T10/07-361r4

To	From	Subject	Date
INCITS T10 Committee	Curtis Ballard, HP Michael Banther, HP	SSC-3 Out of Band Encryption Key Management	2 November, 2007

Figure 8 — UML example of SCSI target device and physical device

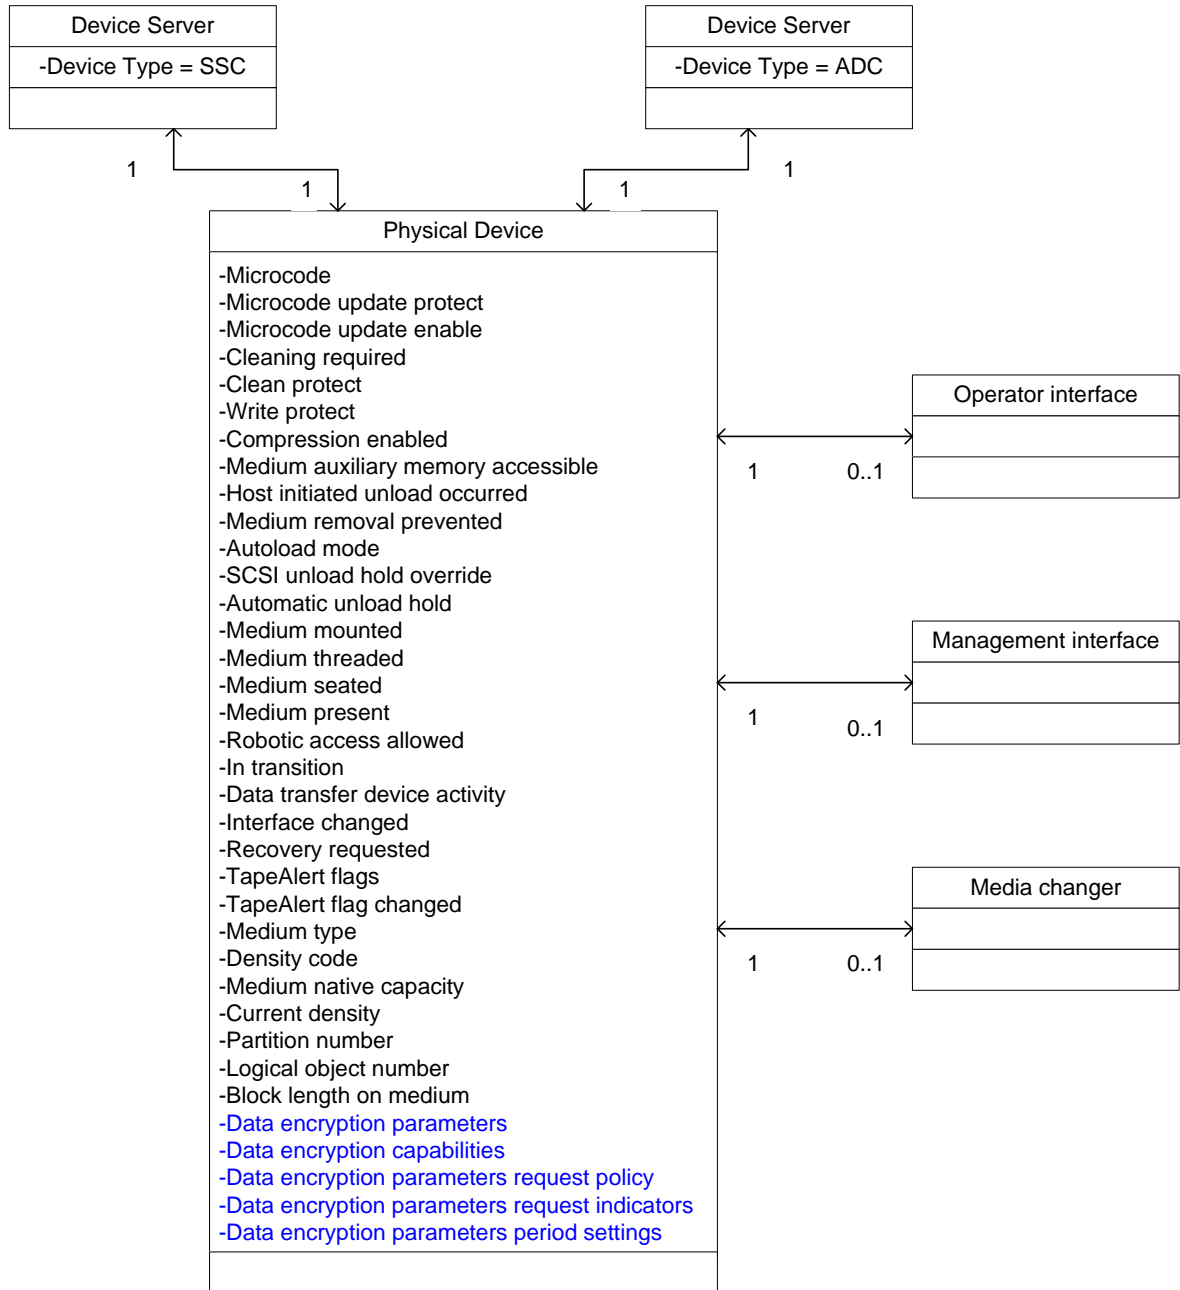
Add data encryption parameters, capabilities, request policy, request indicators, period settings to figure 8.
